Re: Peer Review Comment Response
15 Liberty Way, Franklin MA (DEP File No. 159-1282)

Goddard Consulting, LLC, (Goddard) is pleased to submit this response letter and revised site plans on behalf of Atlantic Oliver 15 Liberty Way LLC (the Applicant), to provide responses to the project review comments issued by BETA Group, Inc. on January 2, 2024, in regard to the Notice of Intent (NOI) filed for 15 Liberty Way, Franklin MA.

1.0 BETA GROUP COMMENT RESPONSES

50-100' Buffer Zone Cover Comparison

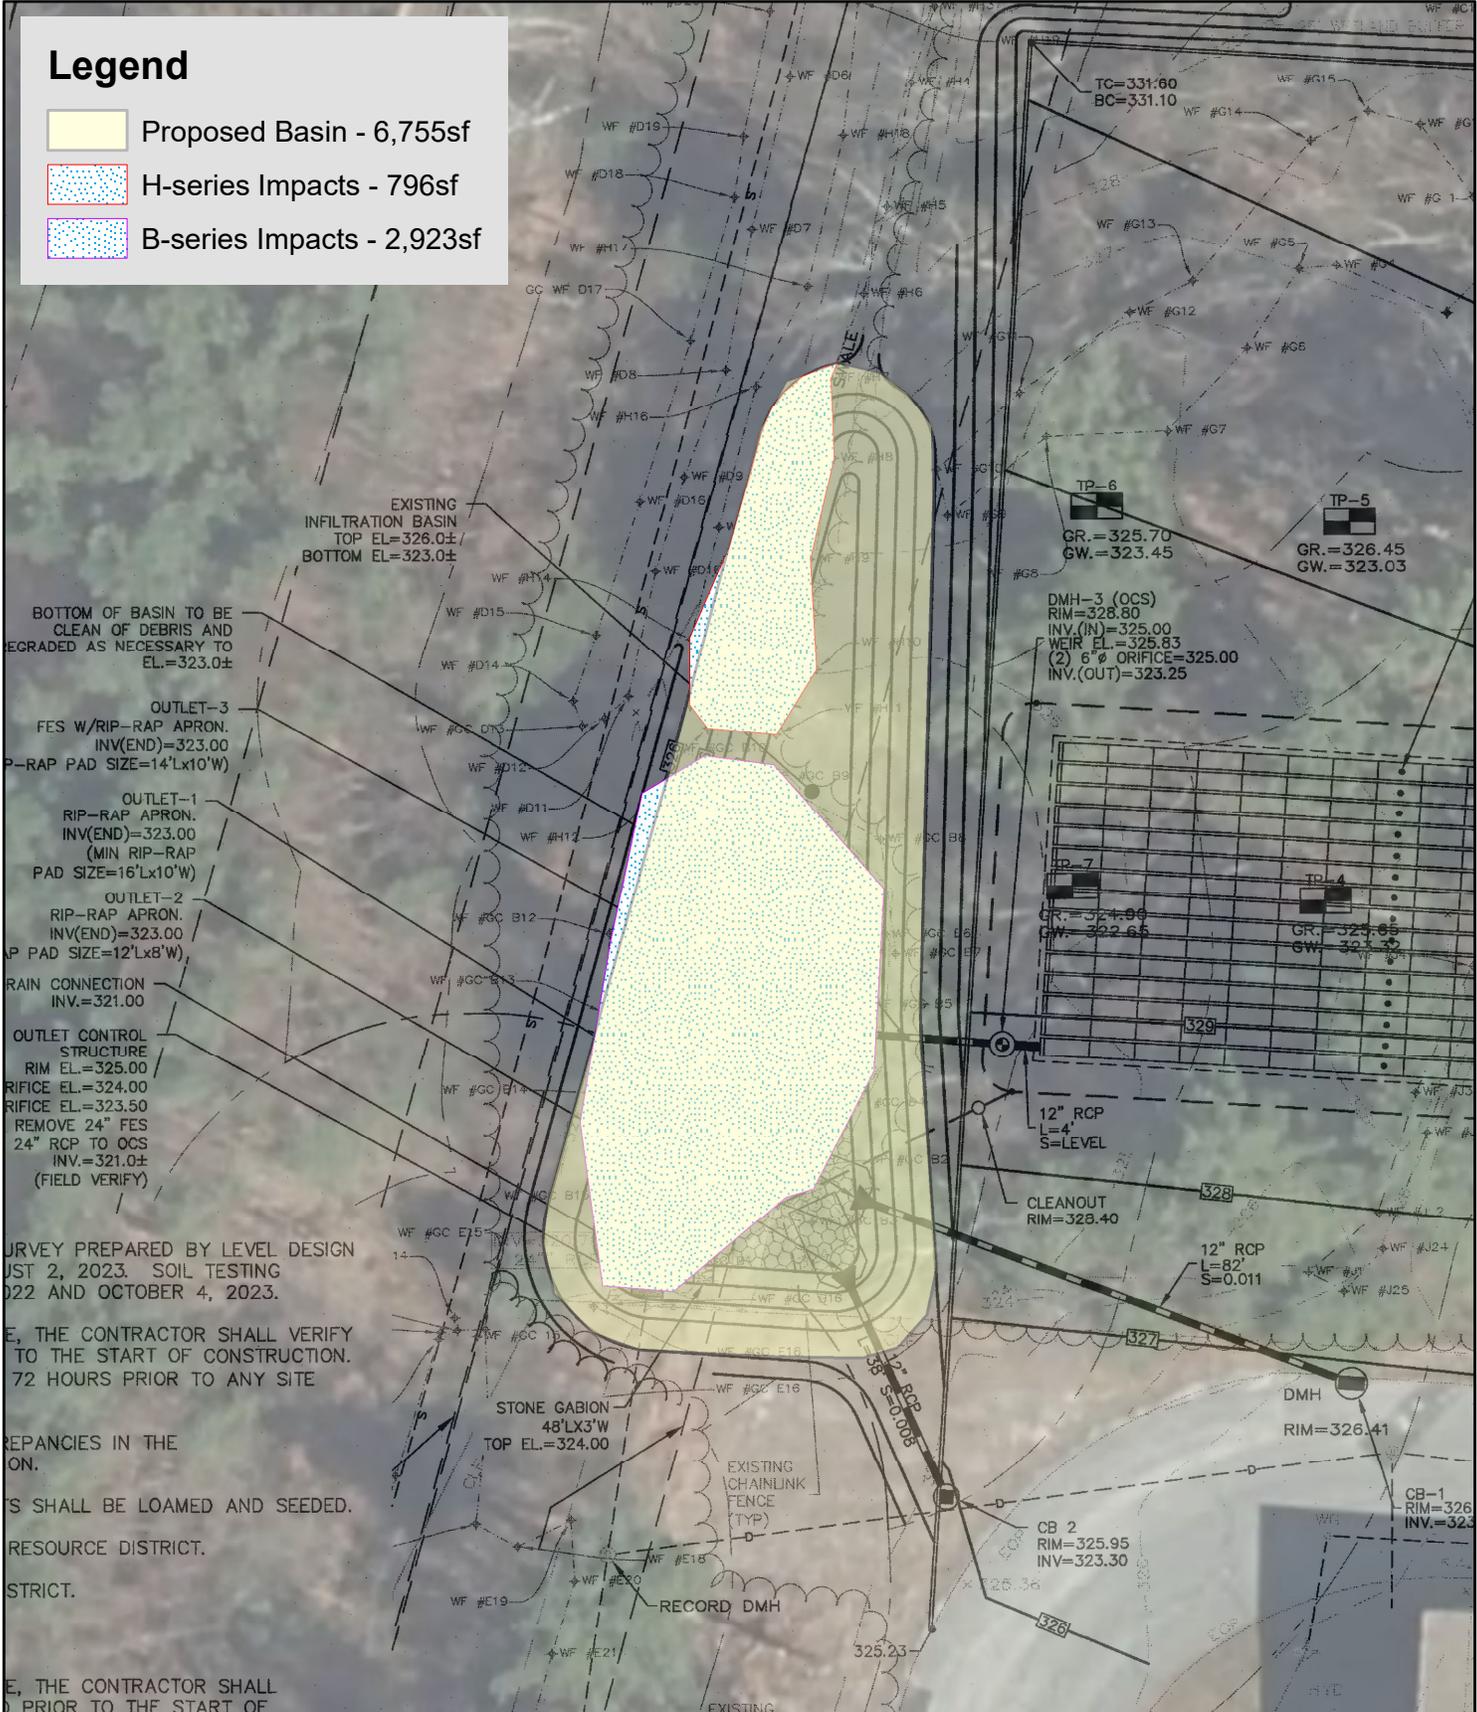
<p>W13</p>	<p><i>BETA2: Comment not addressed. The Applicant should provide the percentage of impervious surface increase associated with the 18,894 sf of impervious surface proposed in the 50-100' Buffer Zone. BETA defers to the Commission for a determination on whether the proposed mitigation is sufficient for the proposed impacts.</i></p> <p><i>BETA3: Comment remains.</i></p>	<p>The total area of the 50-100' Buffer Zone on site is 63,447 square feet. Currently, 11,116 square feet (approximately 17.5%) of the 50-100' Buffer Zone is impervious.</p> <p>Proposed impervious cover in the 50-100' Buffer Zone will be 30,287 square feet (approximately 47.7%), an increase of 19,171 square feet. See attached graphic titled "50-100' Buffer Zone Cover Comparison".</p> <p>Runoff from the entirety of the proposed impervious area will be captured and treated by proposed stormwater management features.</p>

Proposed Basin Planting Plan

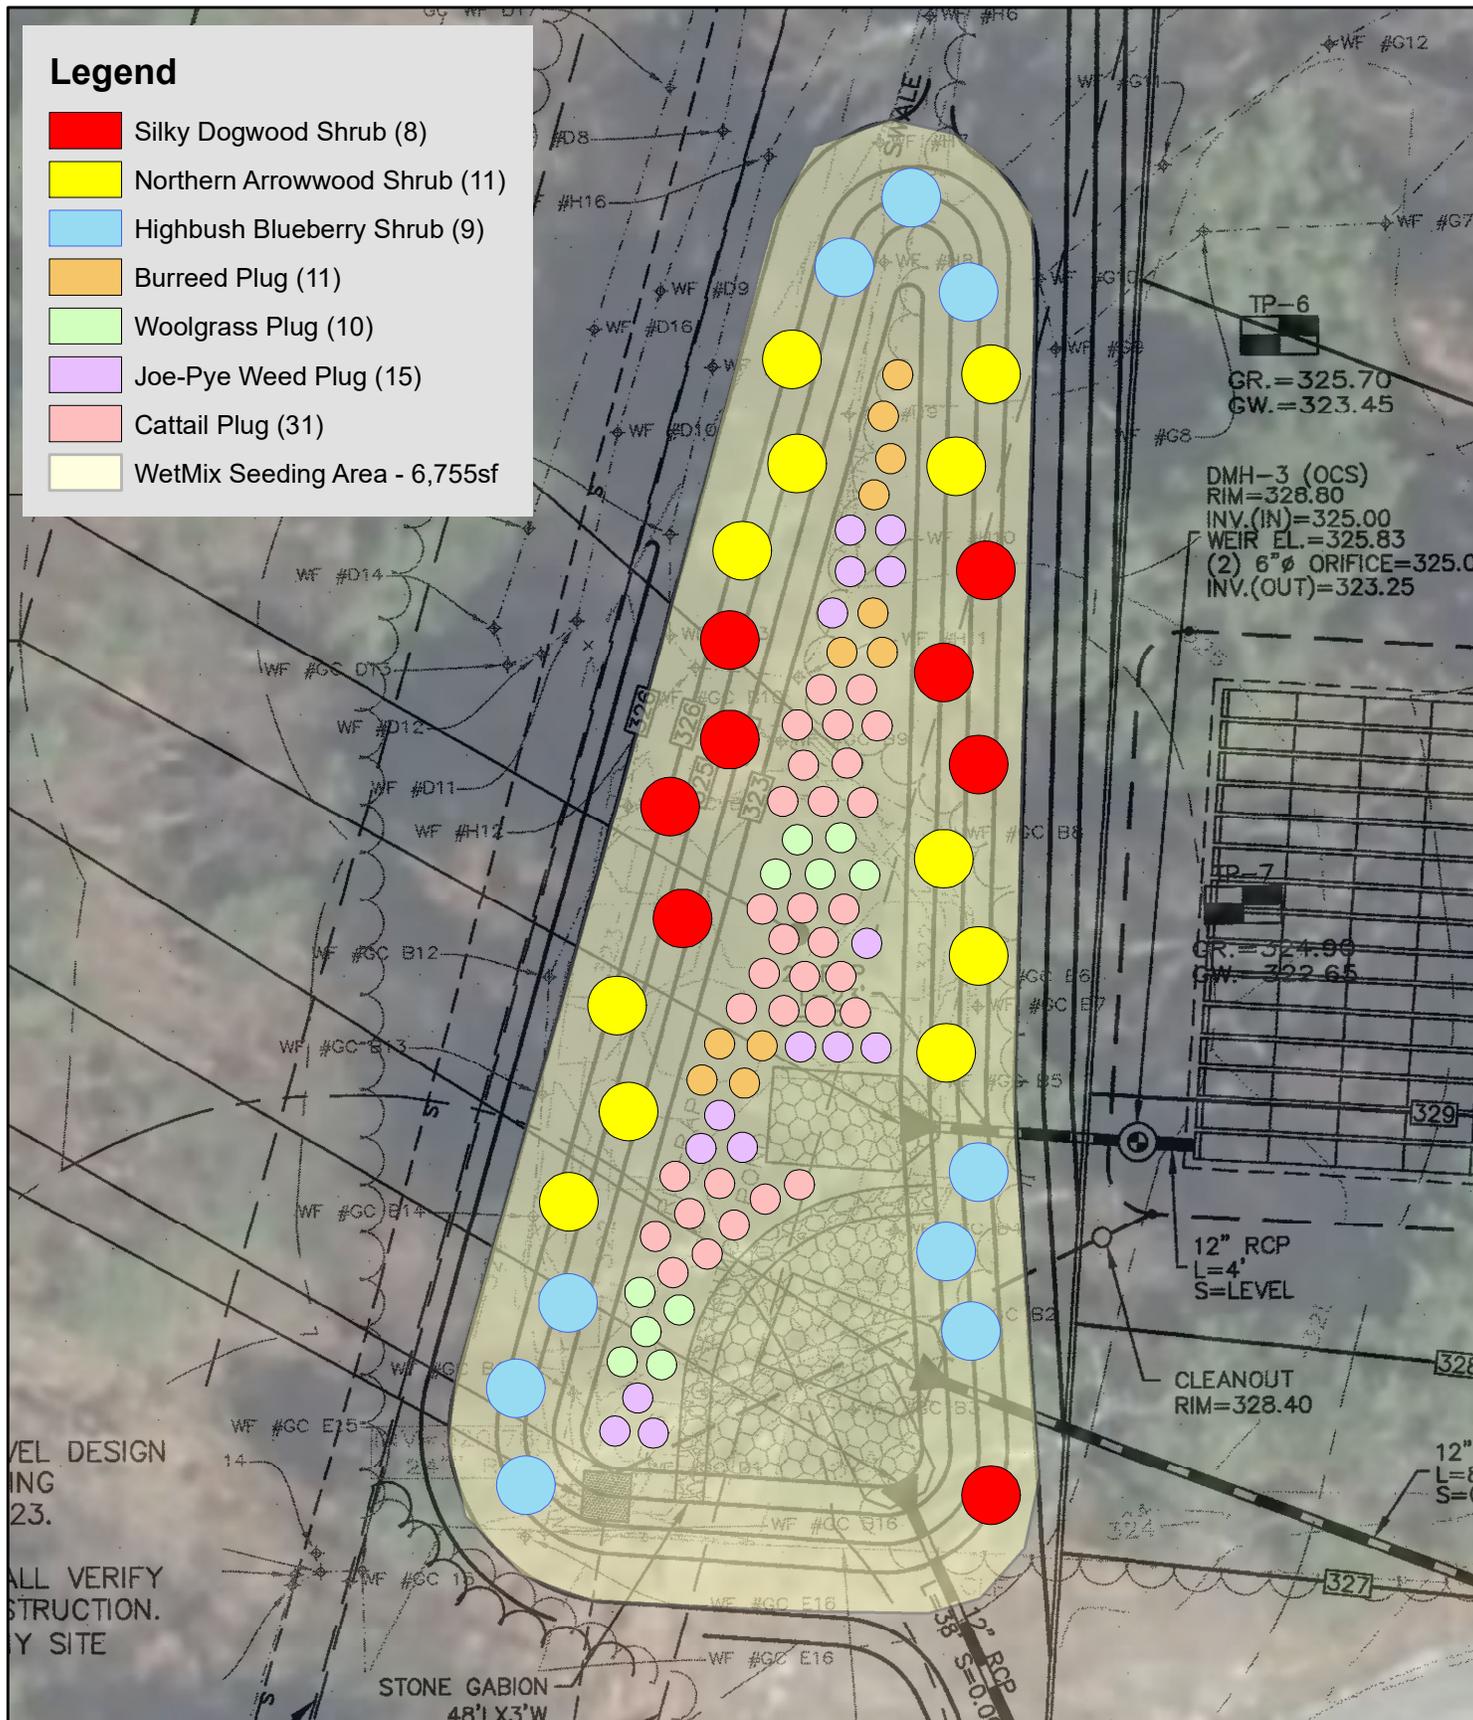
<p>W14</p>	<p><i>BETA3: Comment remains. BETA defers to the Commission for a determination on whether the proposed mitigation is sufficient for the proposed impacts, with the understanding that restoration within the sewer easement will only consist of the application of a native seed mixture in lieu of woody plantings.</i></p>	<p>The Applicant intends to confirm with the Commission that the proposed mitigation is sufficient for project impacts.</p>
<p>STORMWATER MANAGEMENT</p>		
	<p><i>BETA3: Comment remains. BETA most recently submitted a peer review letter to the Franklin Planning Board on December 14, 2023, outlining remaining issues with the proposed stormwater design. The remaining stormwater comments are primarily related to the documented high groundwater at the Site, and the Applicant's proposal to artificially lower groundwater elevations around an infiltration system in order to meet the 2-foot separation to groundwater requirement. It is anticipated that additional stormwater management system design changes will be required, as the Applicant's proposal does not currently provide the level of recharge required to meet the Standards.</i></p>	<p>Review of project compliance with the Stormwater Management Standards is ongoing with Planning Board. Revised materials were submitted on 2/5/2024.</p> <p>As part of the revisions made to the stormwater management design, a new infiltration basin is now proposed in the southwest portion of the work area. This stormwater basin will provide a greater capacity for stormwater treatment and improved functionality, while expanding the size of the stormwater basin/IVW onsite. The expanded stormwater basin/IVW will be planted with appropriate wetland species to aid in removal of contaminants and uptake of water, while replicating the functions and characteristics of the lost stormwater basin/IVW.</p> <p>Impacts to the B- and H-series IVWs total approximately 3,719 square feet. The proposed basin measures approximately 6,755 square feet.</p> <p>Photos of this area can be found in the attached Photo Exhibit. Additional graphics are attached detailing the impacts of the proposed basin, and the proposed planting scheme for the basin.</p>

EROSION CONTROL

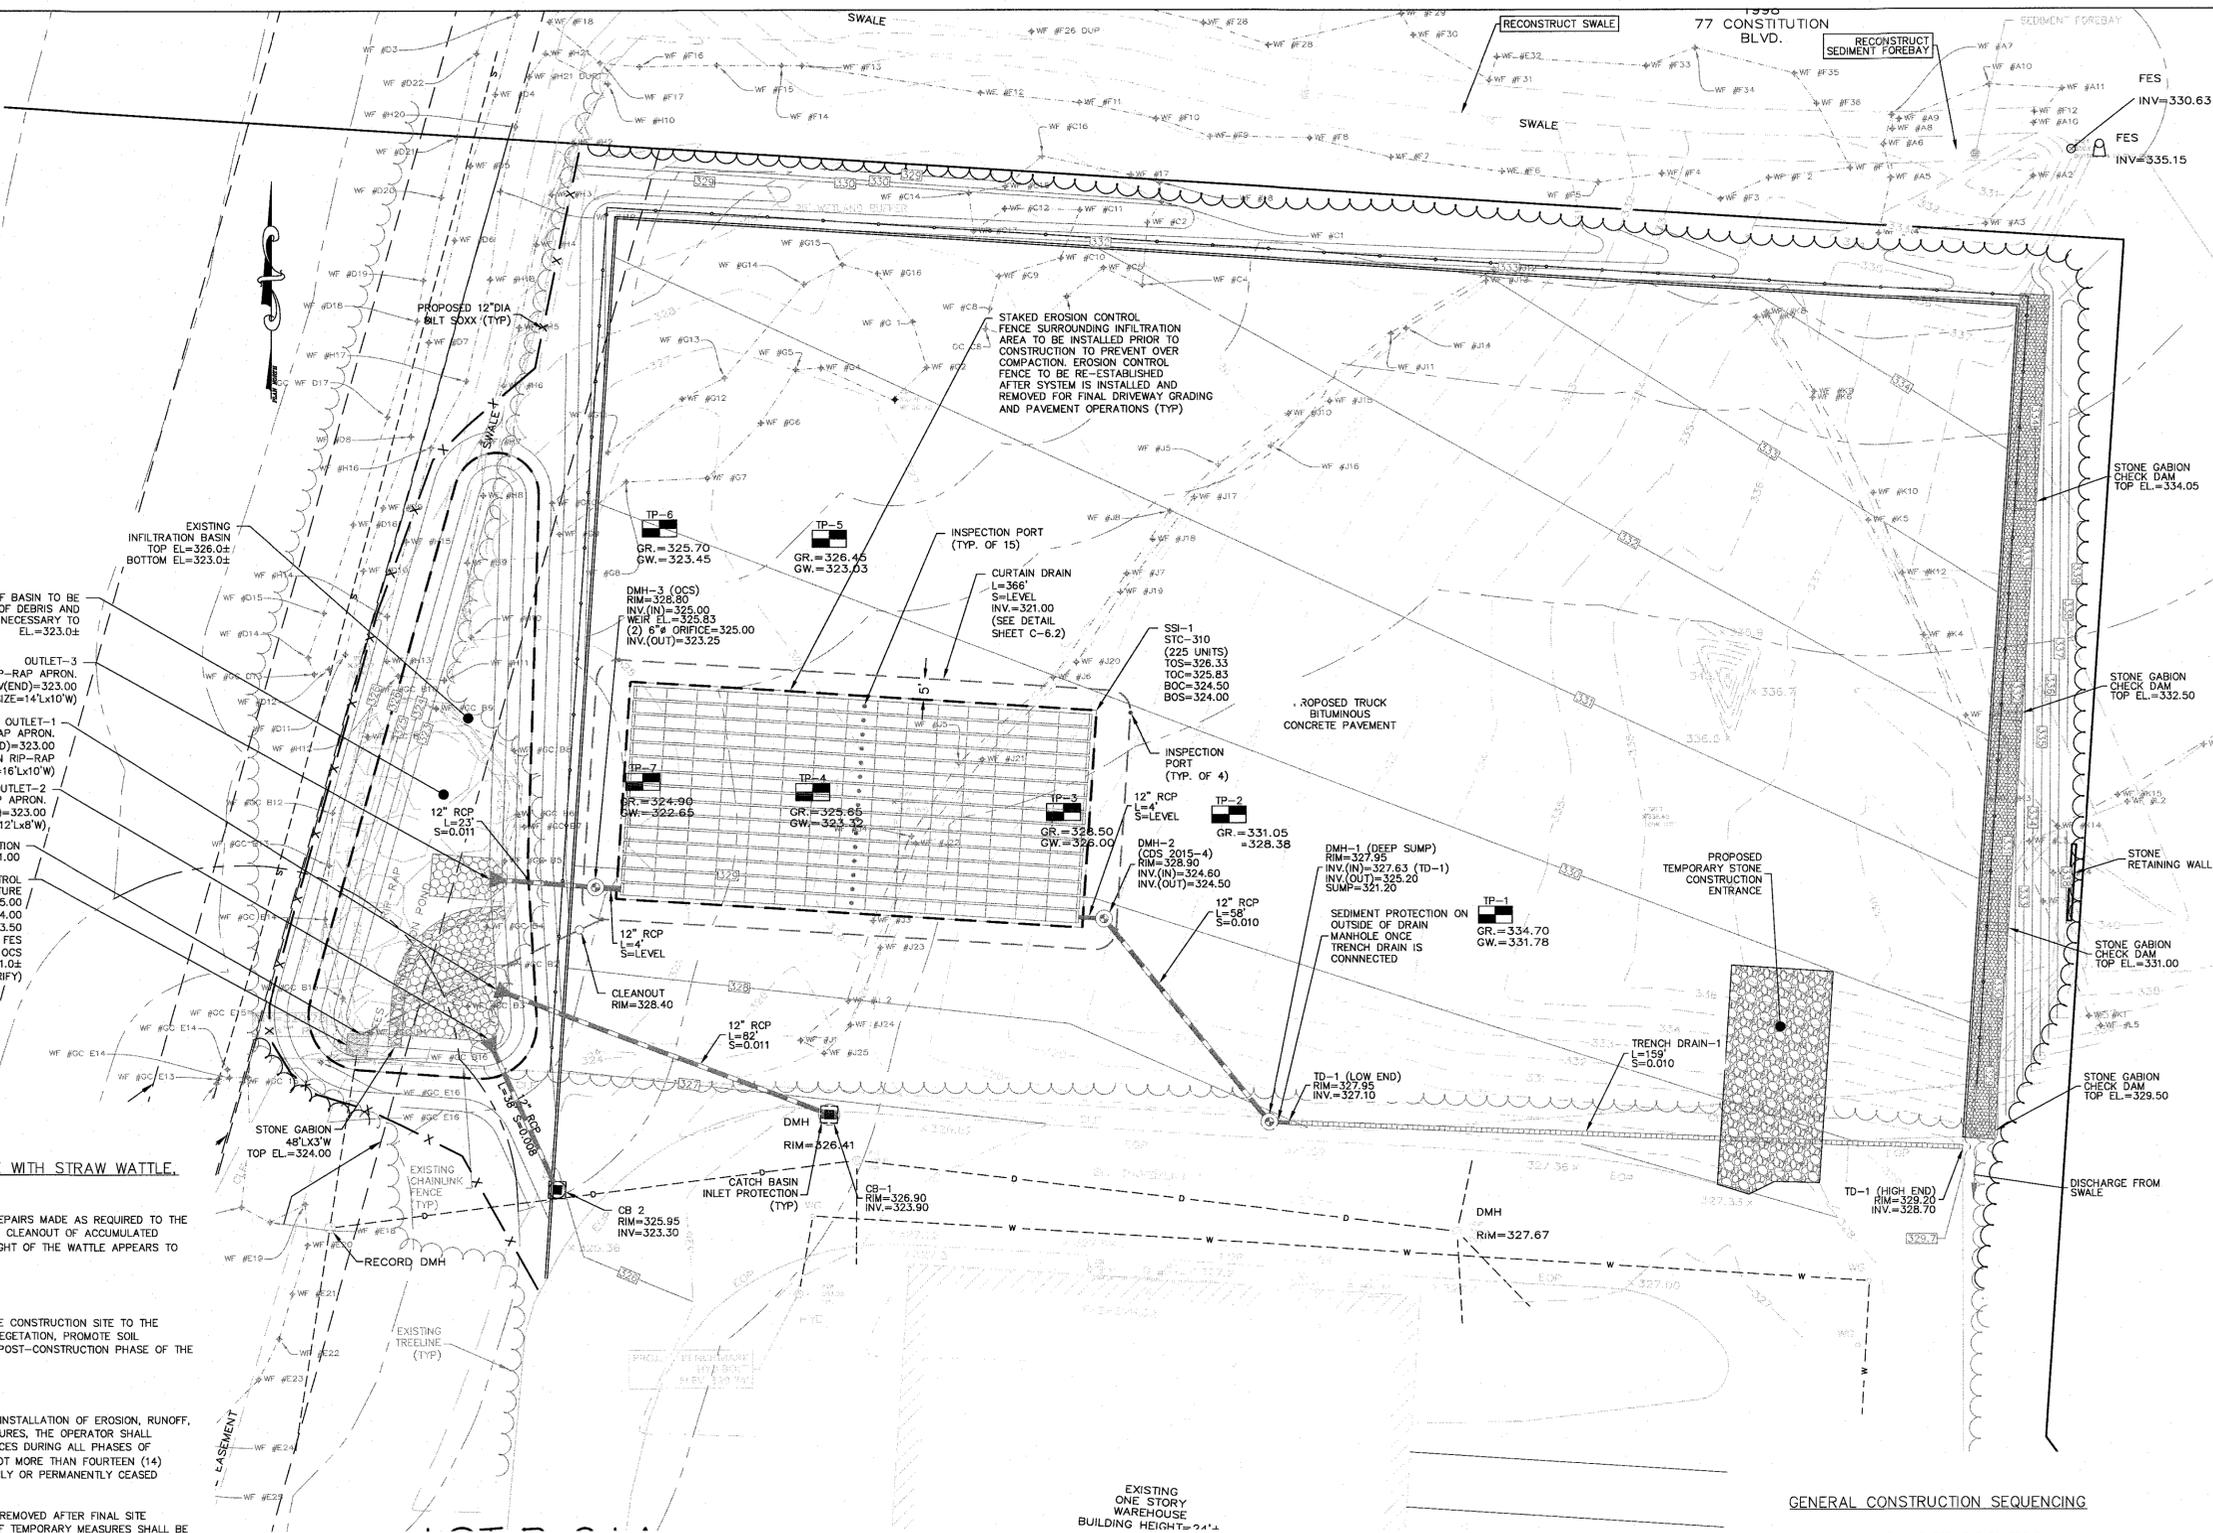
<p>W10</p>	<p><i>BETA2: BETA defers to the Commission for approval of silt fence as an erosion control measure.</i></p> <p><i>BETA3: Comment remains.</i></p>	<p>Goddard and Level Design Group maintain that the erosion controls depicted are appropriate for this project.</p>
<p>W11</p>	<p><i>BETA2: Based on the Project plans, the proposed invasive species management area appears to be located within existing drainage and utility easements. As noted by the Applicant, native herbaceous cover will be established at this location due to anticipated future maintenance of the easements (i.e., mowing). BETA offers the following comments on the provided invasive species management plan.</i></p> <p><i>a. Section 2.2 “Cut-Stem Treatment” requires that target plants be cut flush with the ground and that the cut stems treated with herbicide. When performing cut-stem treatment, however, approximately five (5) inches of the stem should be retained in case resprouting occurs. This will allow for enough material to remain for a second treatment.</i></p> <p><i>b. The time of year for the proposed treatment should be identified in the invasive species management plan. Cut-stem herbicide treatment is most effective in the late summer or early fall.</i></p> <p><i>c. Additional species identified in the invasive species management plan such as multiflora rose (Rosa multiflora) and honeysuckle (Lonicera spp.) could also be treated using cut-stem method. This method would result in less soil disturbance than grubbing and would ensure a higher kill rate for the undesirable species. The Applicant should indicate if use of this method for treatment of those species was reviewed, and if so, why it is not the preferred treatment method for those species.</i></p> <p><i>BETA3: Comments W11.a. through c. have not been addressed. Comment remains.</i></p> <p><i>BETA understands that a portion of the proposed invasive species management will occur within a Town sewer easement and that the Applicant has coordinated with the Town of Franklin Department of Public Works (DPW) regarding the Project. It is also BETA’s understanding that woody plantings are not</i></p>	<p>a. Section 2.2 has been revised to indicate that ~5” of stem will remain to allow for follow-up treatments.</p> <p>b. The invasive species management plan has been revised to encourage late summer or early fall treatments.</p> <p>c. Other species such as multiflora rose, and honeysuckle are indeed viable candidates for cut-stem treatment. Manual removal was specified to minimize the amount of herbicide required. The invasive species management plan has been revised to allow for cut-stem treatment of these species as well, in order to reduce soil disturbance and improve the kill rate, assuming the maximum application rate is not exceeded.</p> <p>The invasive species management plan has been revised to call for multiple rounds of seeding if necessary.</p> <p>The Applicant will accept a Special Condition requiring the submittal and approval of a planting plan once remaining native species cover has been assessed.</p>
